TITLE : AIR CONDITIONING – COCKPIT AND CABIN TEMPERATURE CONTROL – RELOCATE
COCKPIT TEMPERATURE REGULATION SENSOR.

This page transmits Revision No. 02 of Service Bulletin No. A320-21-1112

SERVICE BULLETIN No. : A320-21-1112

REVISION No. : 02 – Dec 21/00

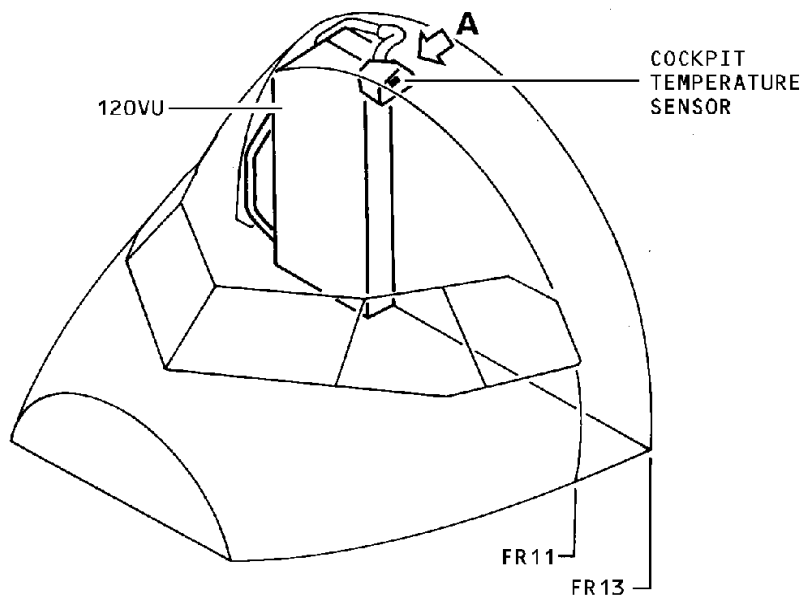
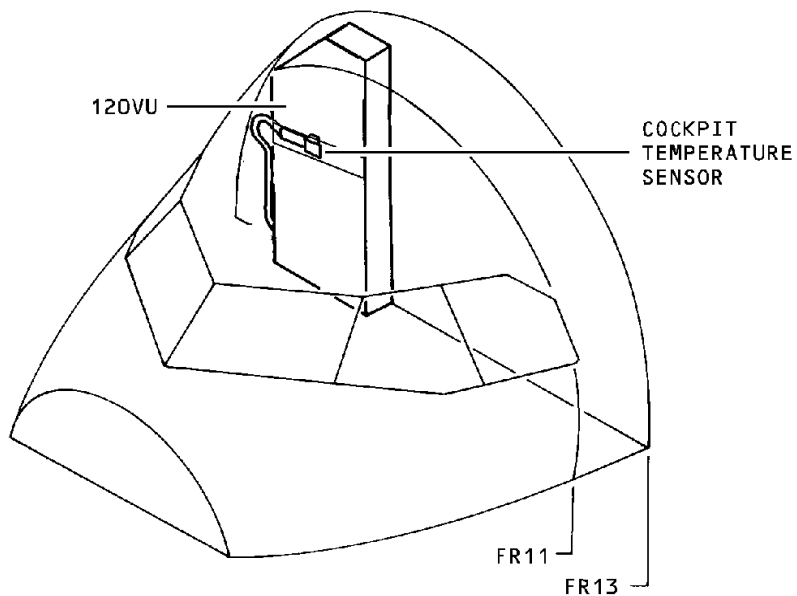
One operator reported that the crew felt cold in the cockpit, particularly during long night flights. Investigation revealed that the low temperature was due to the location of the temperature sensor, fitted at the upper part of the cockpit.

Since the operator usually closes the cockpit air outlets, the air circulation within the cockpit is reduced, which leads to differential temperatures being felt, warmer temperatures at ceiling level and colder temperatures at feet level.

This Service Bulletin relocates the temperature sensor at mid-height, on the Rear Panel 120VU.

Accomplishment of this Service Bulletin leads to a better temperature control in the cockpit, thus improving crew comfort.

Figure 1 Sheet 1
Modification to the Equipment in the Cockpit (Config. 01 and Config. 02)

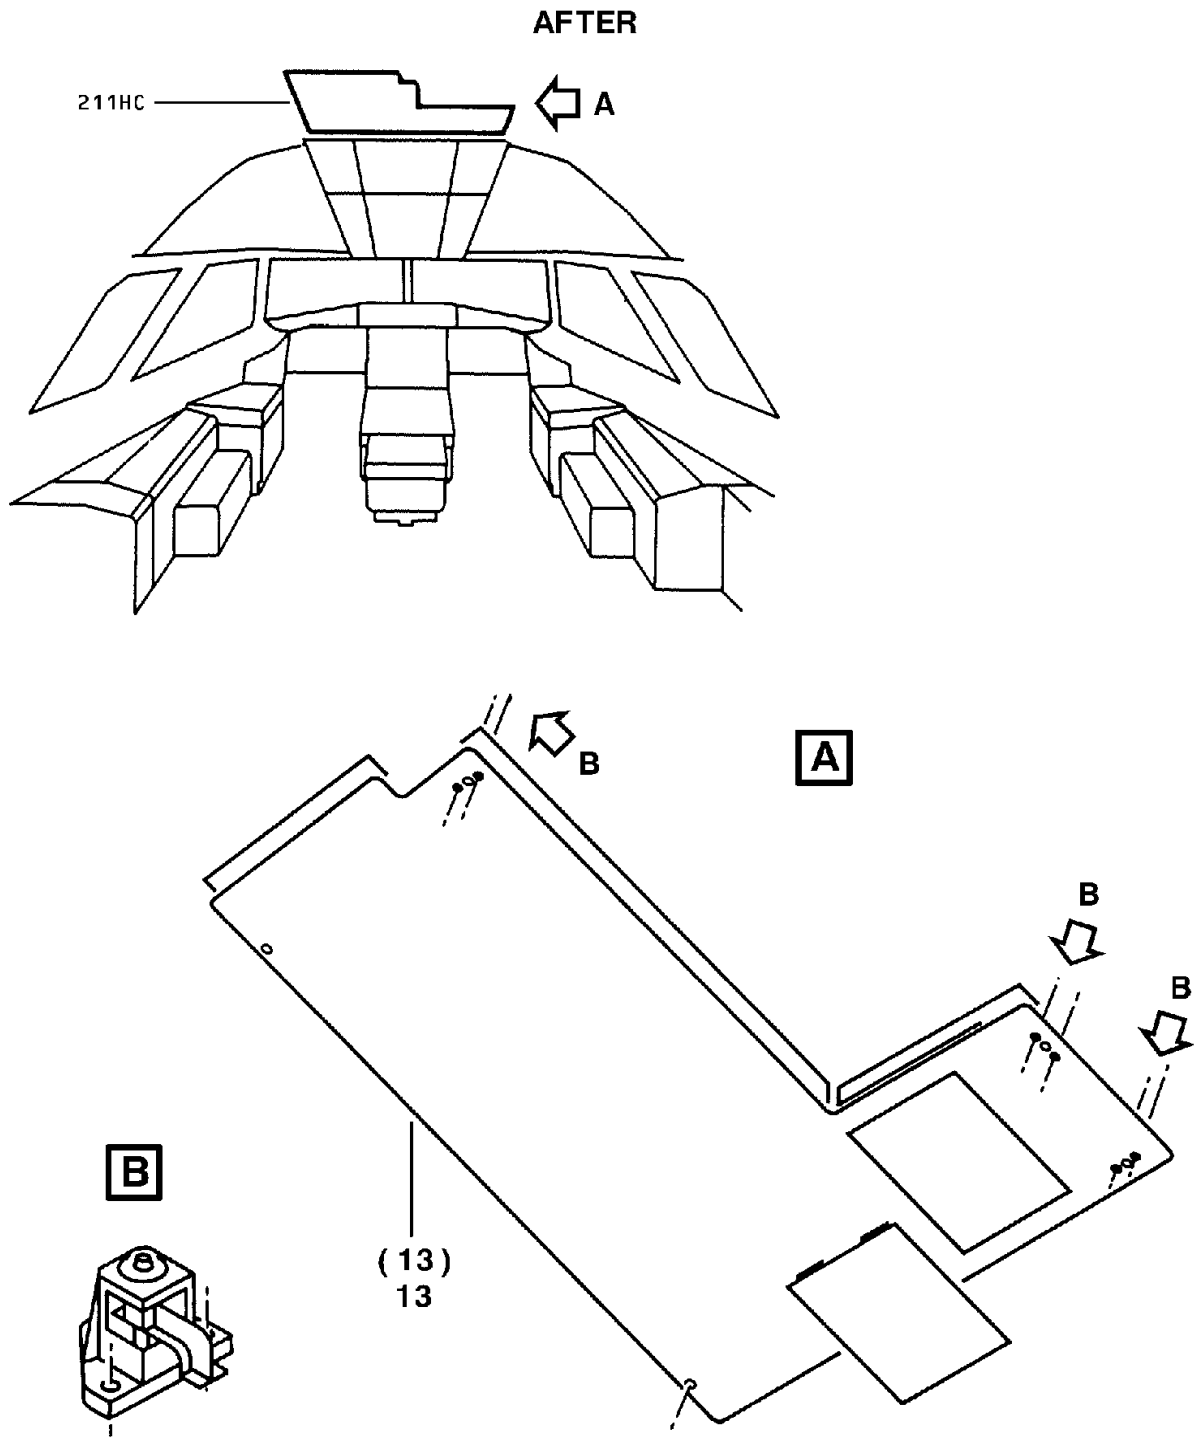
1	Temperature Sensor	Item (40)	Retain
---	--------------------	-----------	--------
 - 2 Remove the panel 211HC :
(Refer to AMM 25-13-41 Page block 401)
Refer to figure 1

1	Panel	Item (13)	Discard
---	-------	-----------	---------
 - 3 Remove the wires shown on the lines 1 thru 9 (Refer to figure 25).
 - 4 Remove the connector 21HK-A
Refer to figure 13
 - 5 Install the panel 211HC :
(Refer to AMM 25-13-41 Page block 401)
Refer to figure 1

Figure 2 Sheet 1
Removal of the Attachment Fitting of the Temperature Probe Casing (Config. 01, Config. 02 and Config. 03)

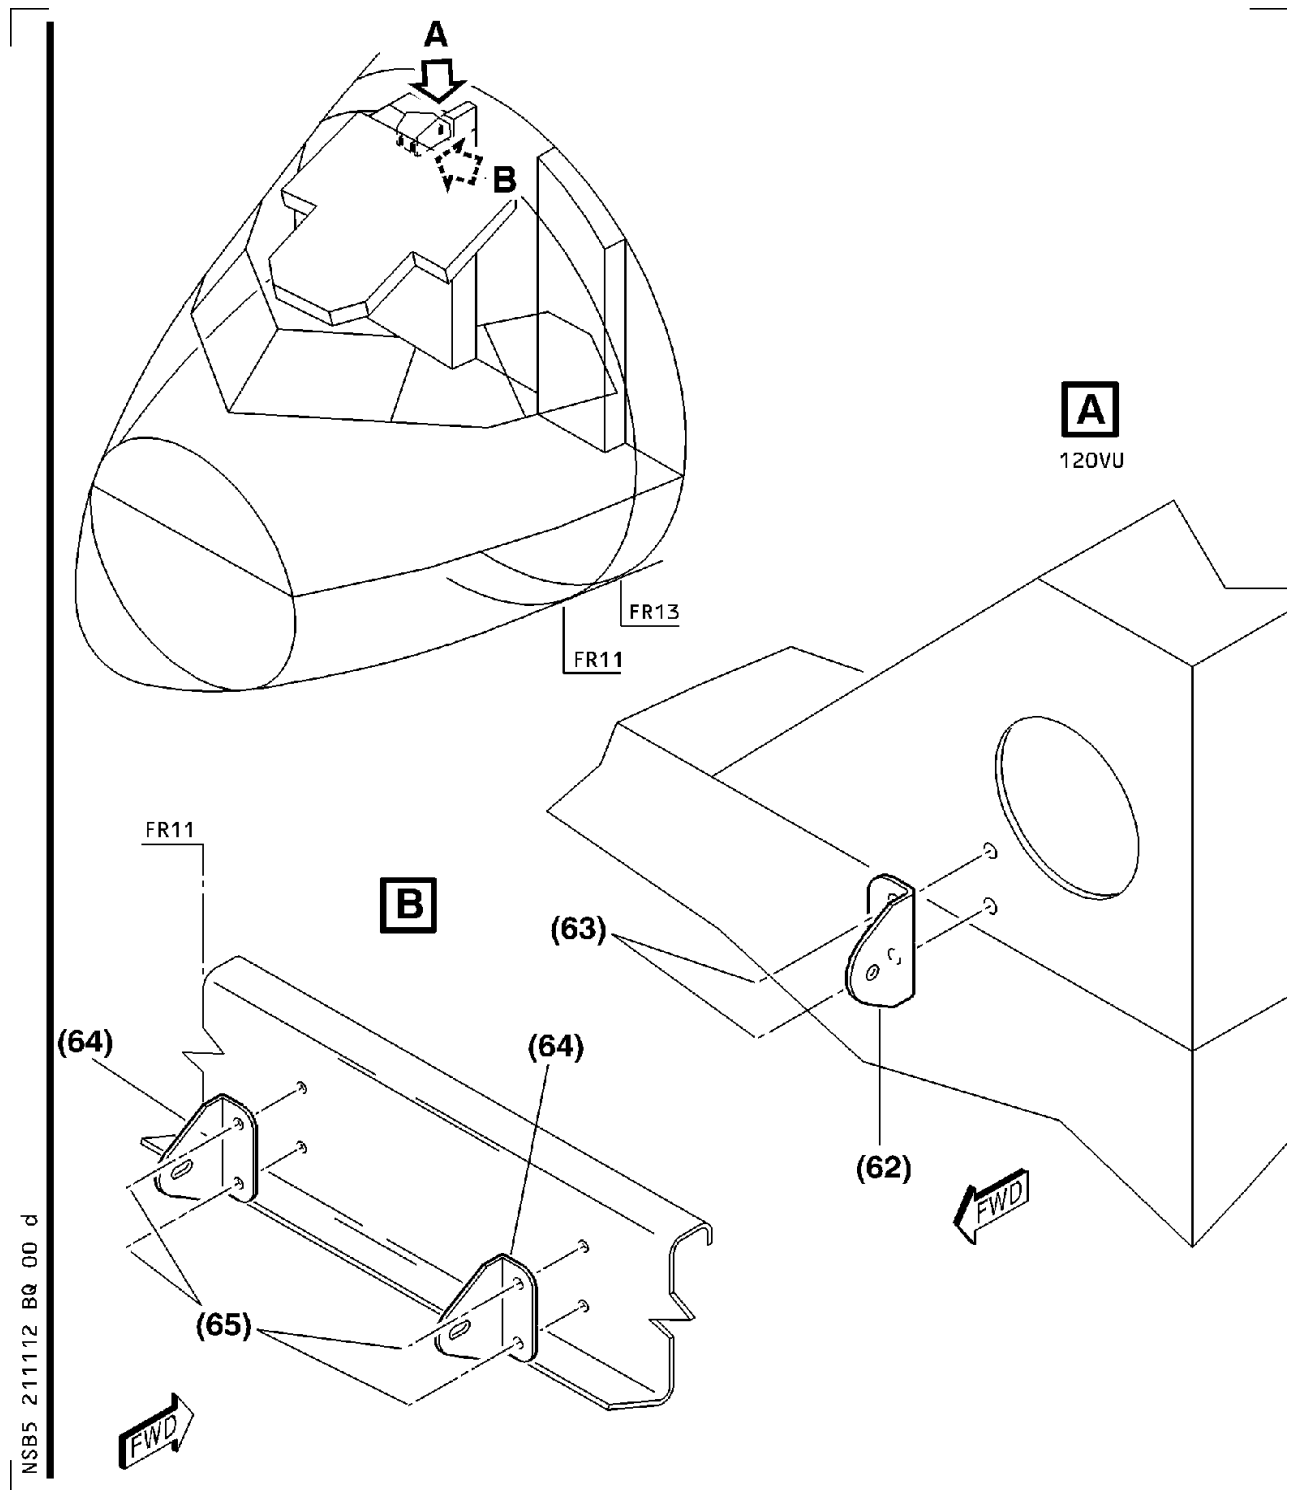
11 From the forward reinforcement plate of the electrical bay and from the Aft Crossbeam 20VU, remove :
Refer to figure 2

9 From the forward reinforcement plate of the electrical bay
and from the Aft Crossbeam 20VU, remove :
Refer to figure 2

6 From the forward reinforcement plate of the electrical bay
and from the Aft Crossbeam 20VU, remove :
Refer to figure 2

Figure 5 Sheet 1
Modification to the Equipment in the Rear Panel 120VU (Config. 01)

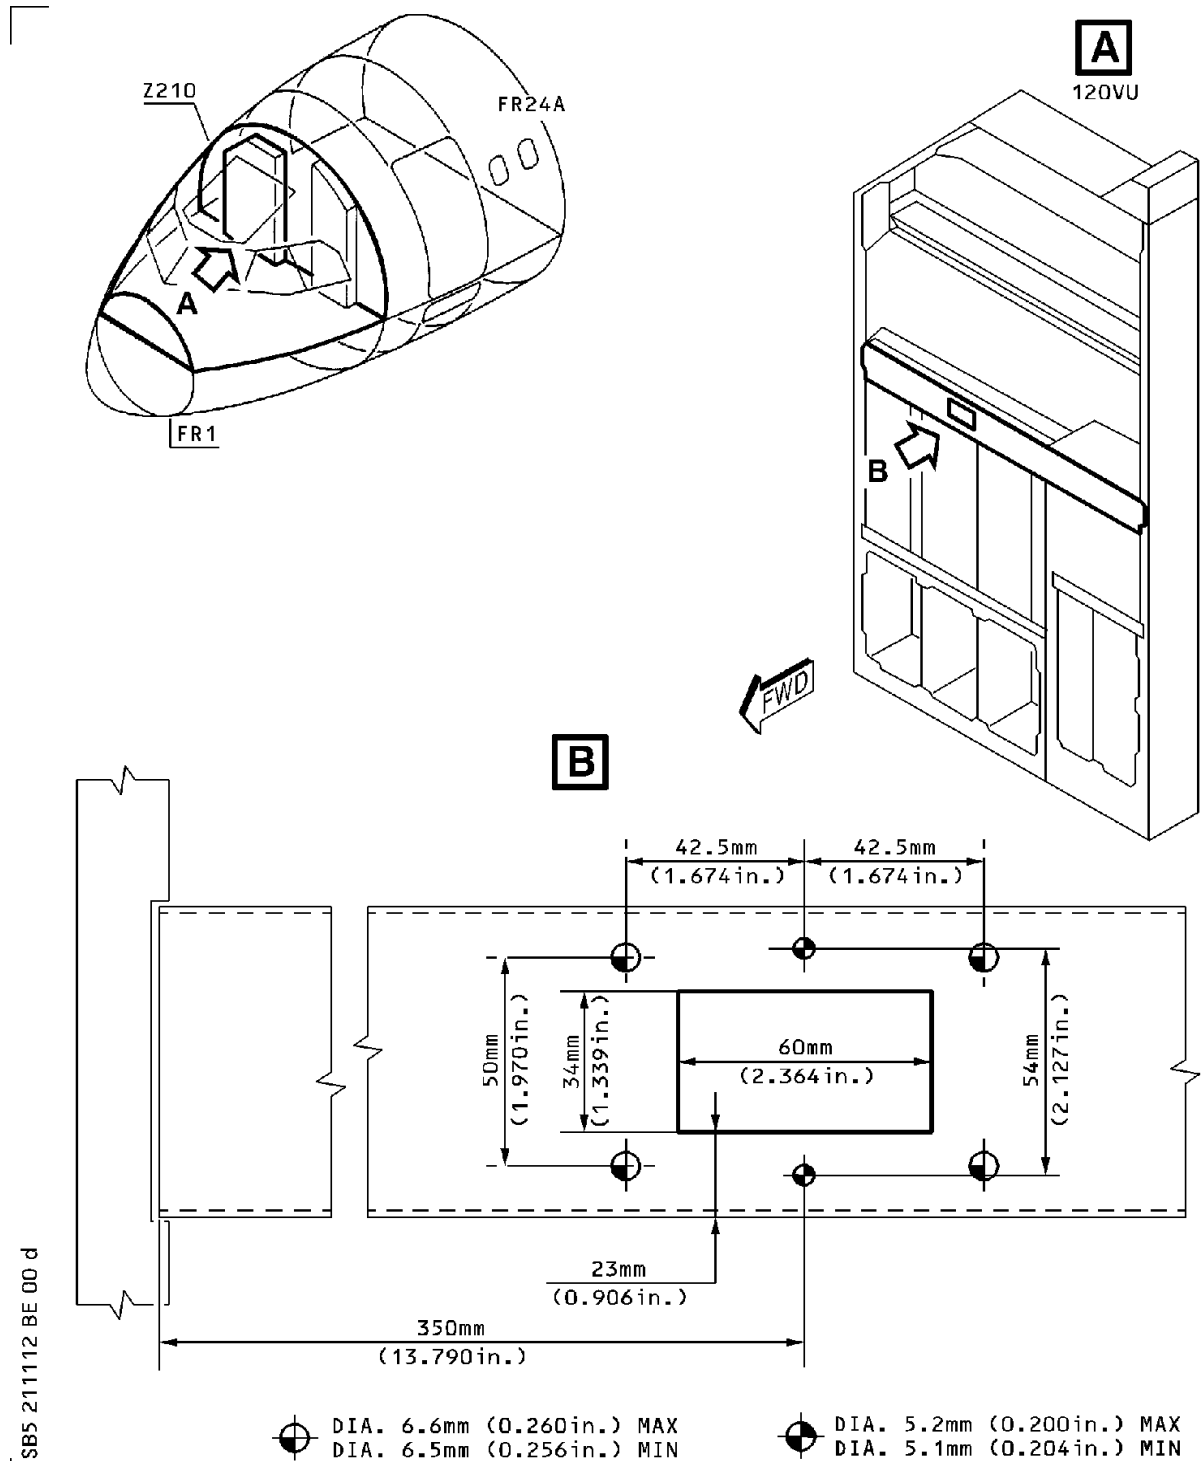
3 On the front face of the Rear Panel 120VU, drill the holes,
(Refer to figure 5).

Figure 3 Sheet 1
Modification to the Equipment in the Cockpit

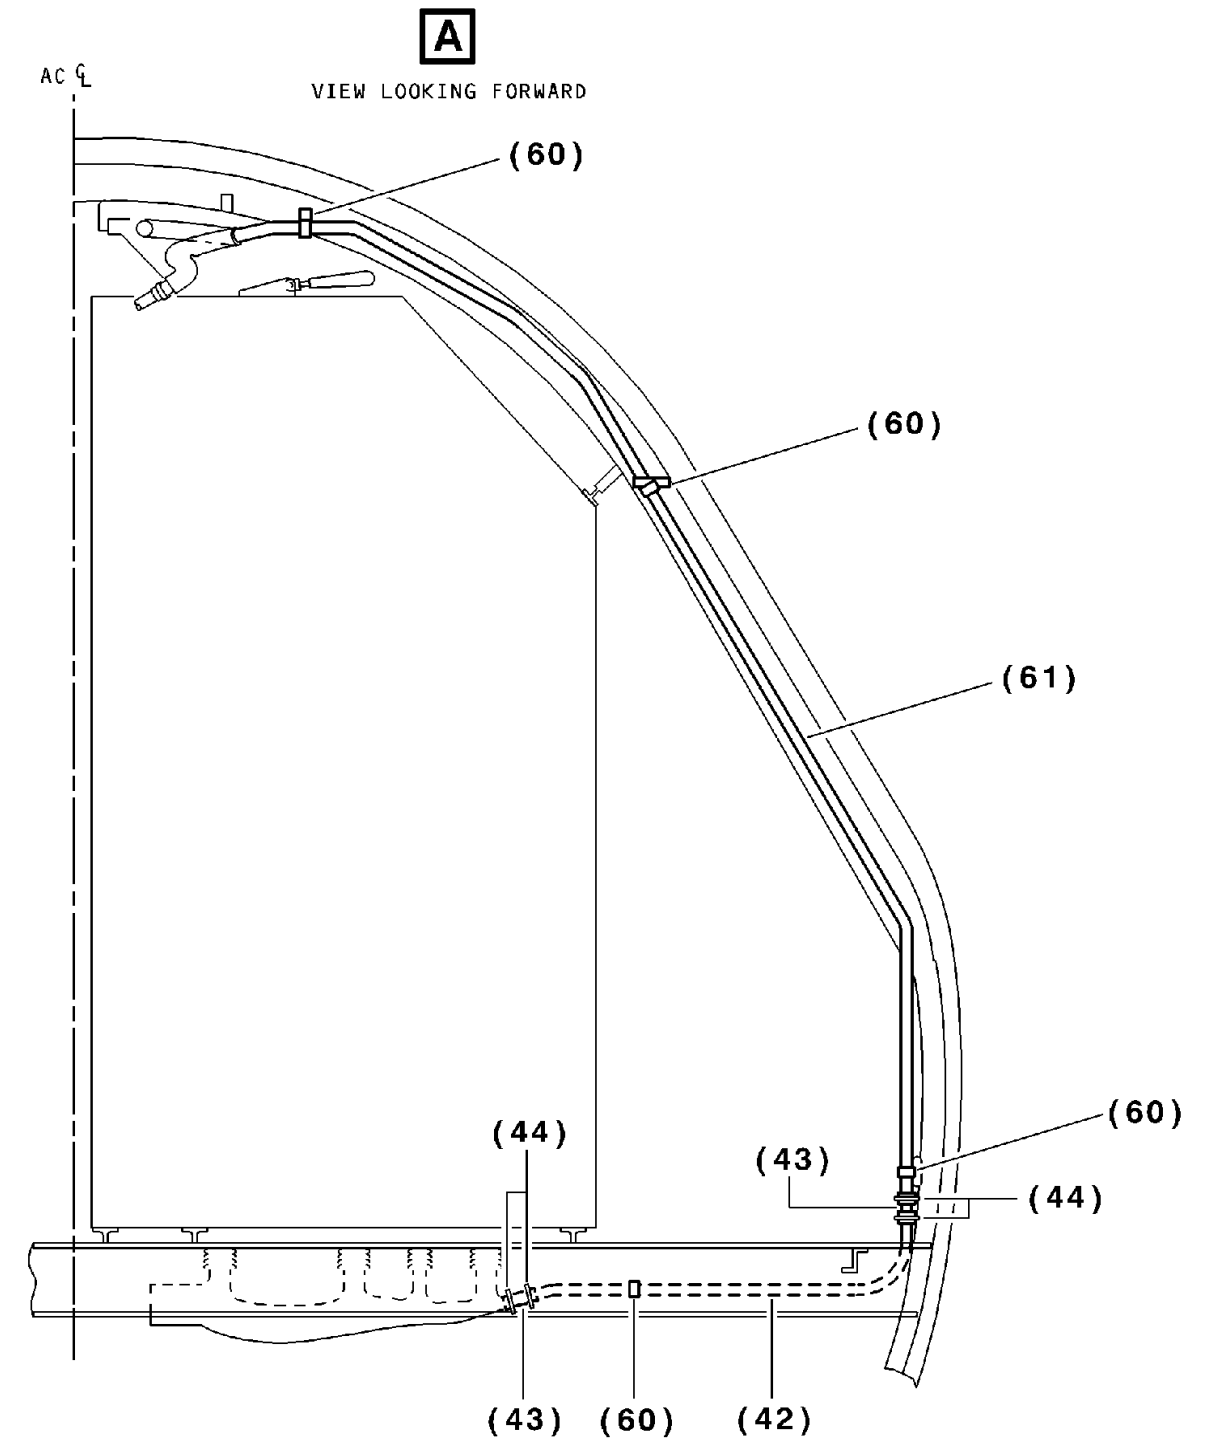
8 Below the floor, remove :
Refer to figure 3

10 In front of FR13, on the RH side, remove :
Refer to figure 3

Figure 3 Sheet 2
Modification to the Equipment in the Cockpit

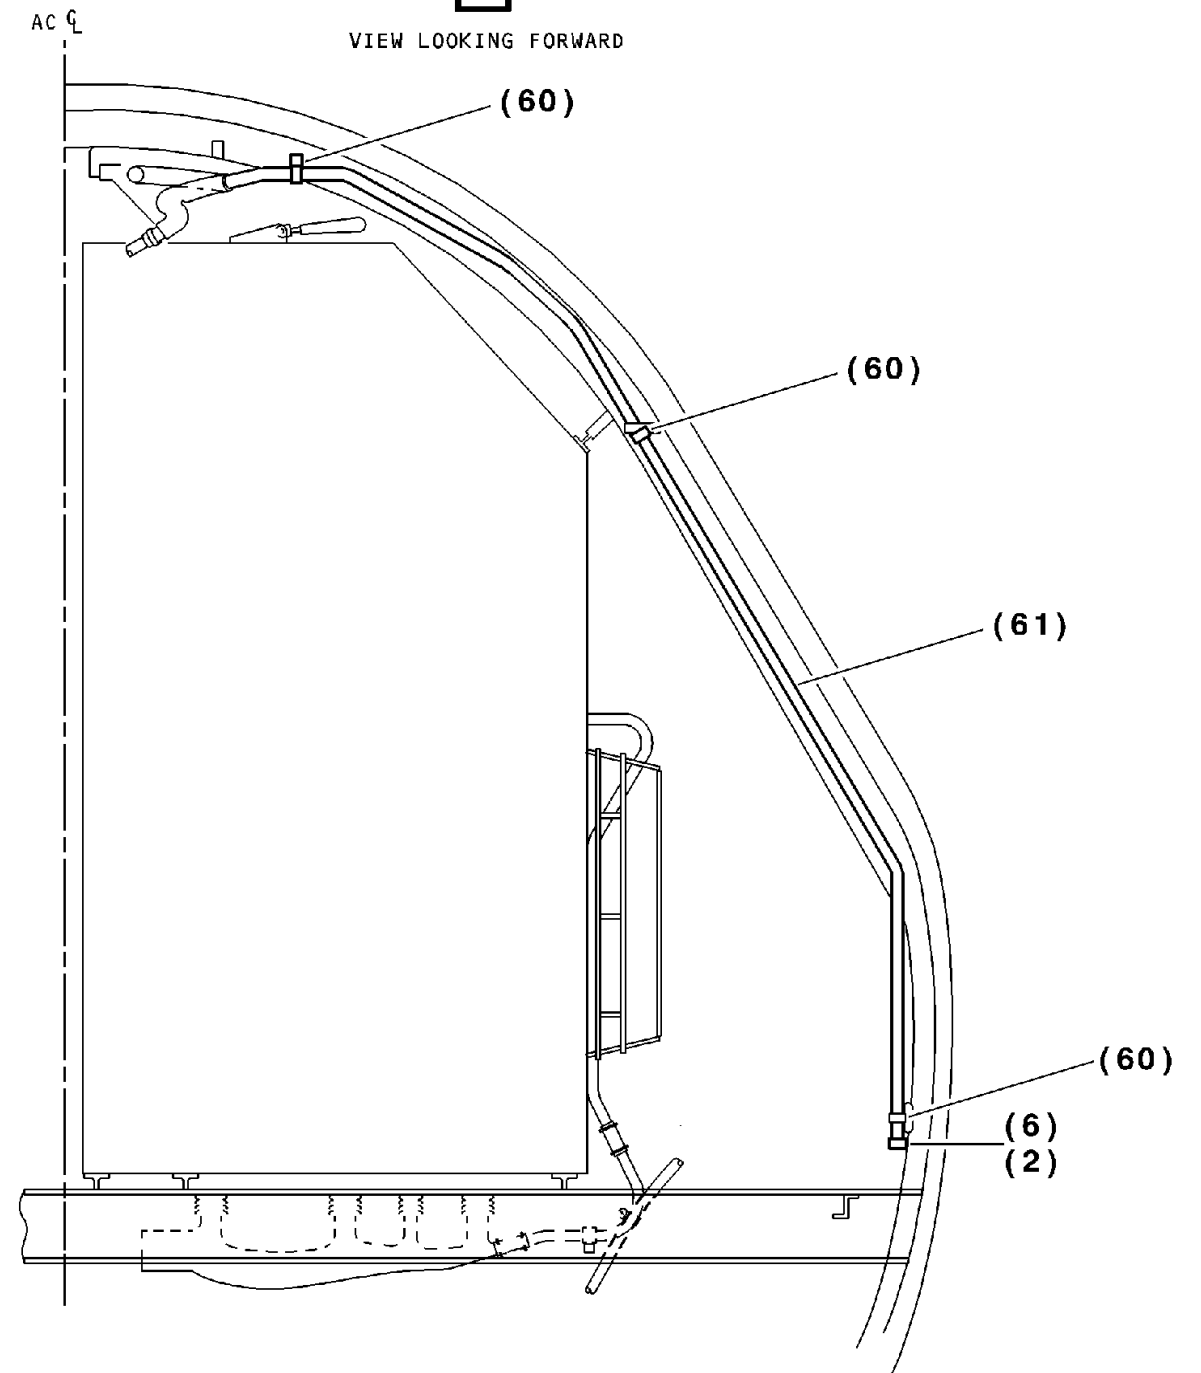
- GENERAL
AMM reference 52-12-11 becomes 53-12-11. Removal of the forward galley unit added. Sentence concerning Mat. No. 16-001 added.
- MODIFICATION
Paragraph updated. Config. 01, Config. 02 and Config. 03 added. Figure references updated.
- TESTS
Paragraph (1), installation of the forward galley unit and connection of the battery connectors added. Paragraph (2), updated to add Config. 01, Config. 02 and Config. 03. Test after the removal/installation of the forward galley unit added.
- CLOSE-UP
AMM reference updated.
- Figure 1
Title updated.
- Figure 2
Added.
- Figure 3
Title and figure updated. Sheet 2 added.
